Amendments to the Drawings:

REMARKS/ARGUMENTS

In response to the Office Action of June 6, 2006, Applicant requests re-examination and reconsideration of this application for patent pursuant to 35 U.S.C. 132.

FIGURE 2

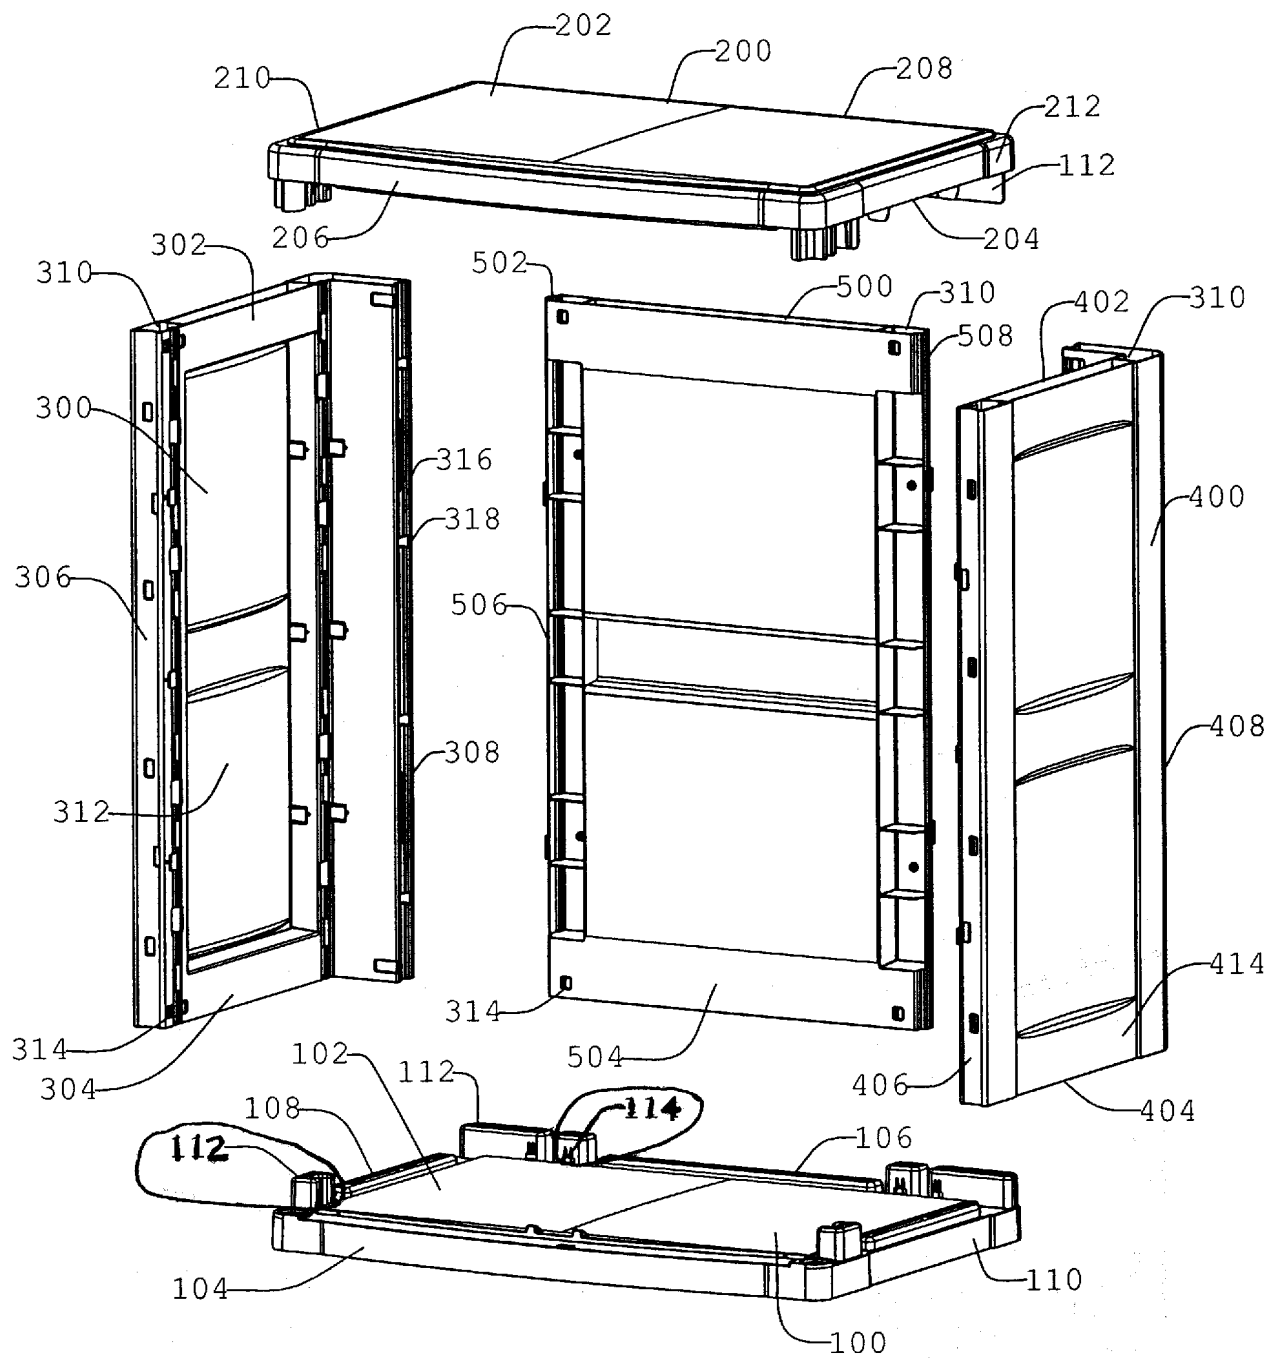
The attached sheet of drawings includes changes to Figs. 2 and 5. These sheet, which includes Figs. 2 and 5, replaces the original sheets including Figs. 2 and 5. In Figure 2, spring tab 114 has been identified. In Fig. 5, spring tab 114 has been identified.

In amended Figures 2 and 5, the previously omitted element numerals 114 has been added.

The drawings are objected to under 37 CFR 1.83(a) for not showing the spring tabs mentioned in claims 5, 12, and 14. The spring tabs of claim 5 are illustrated as element 114 in Figure 3. The spring tabs of claim 12 are now illustrated as elements 114 on the base panel locking posts in amended Figures 2 and 5. The spring tabs of claim 14 is illustrated as element 114 on the top panel locking post in the upper left portion of Figure 5.
